Errata

MPC8240CE
Rev. 5, 1/2004

MPC8240
Integrated Processor
Chip Errata

Figure 1. IDSEL Qualifying Logic

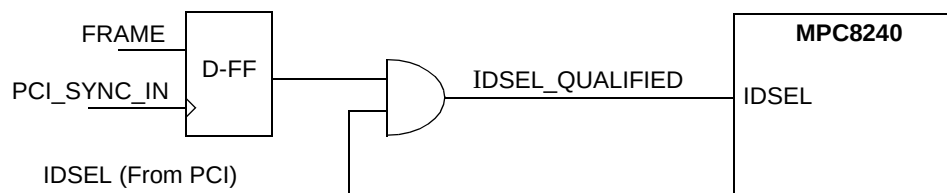
This is a problem when the MPC8240 is operating in peripheral (agent) mode and is a potential problem in host mode if the IDSEL pin of the MPC8240 is not pulled down to a logic 0.

In peripheral mode, external logic needs to be added to qualify the IDSEL input to the MPC8240 in such a way where the IDSEL input will not be asserted after the address phase of any PCI transaction. See Figure 1. This may introduce a timing problem as $\overline{\text{FRAME}}$ and IDSEL are involved in order to generate the qualified IDSEL signal to the MPC8240 during the cycle when $\overline{\text{FRAME}}$ transitions from logic 1 to logic 0. See Figure 2.

In host mode, we recommend to pulldown the IDSEL input on the MPC8240. In general, this is an acceptable solution for host mode operation as PCI configuration cycles are normally issued by the host controller.
